Technical News Bulletin

Cham, 17 November 2015

FlexIS Drive Replacement

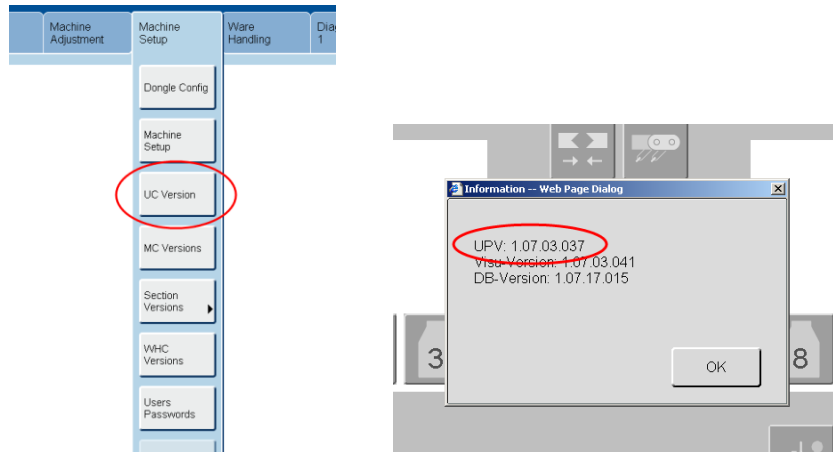
The dimensions and mounting of the drive have not changed.

X73
Safety (STO) input

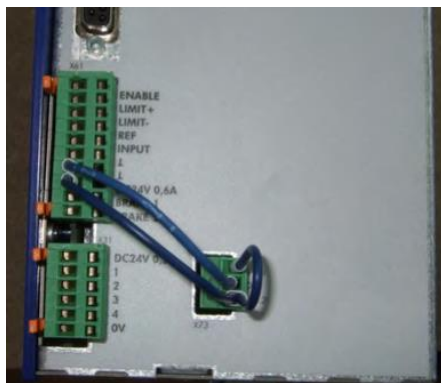
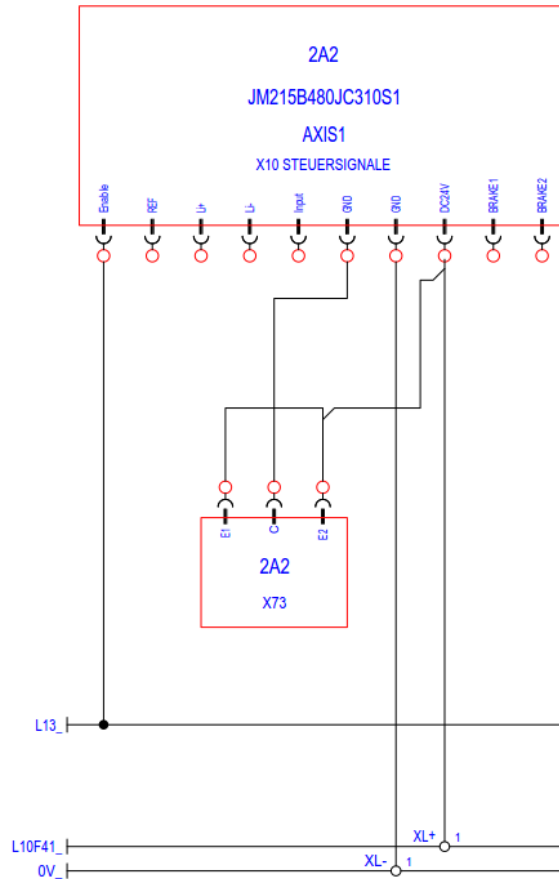
All new drives have a safety input to safely disable the drive (STO = Safe Torque Off). The old JetMove JM-215 (601-10146) did not have this safety input.
When replacing a JetMove JM-215 (601-10146) by a new model it’s necessary to add some wiring.
The safe enable inputs need to be powered with 24V.
If your FlexIS is still using the JM-215 then we recommend that you prepare the wiring for all drives.

Below you can see how to wire up the safe enable inputs.
E1 and E2 need 24V which can be taken from the 24V supply of the drive.
C needs 0V which can also be taken from the 0V supply of the drive.

To receive the new drive (601-10847) including the wiring (601-20103) please order the drive replacement kit (601-10847-Kit)

If you wish you can order the wiring kit 601-20103 for the upgrade.
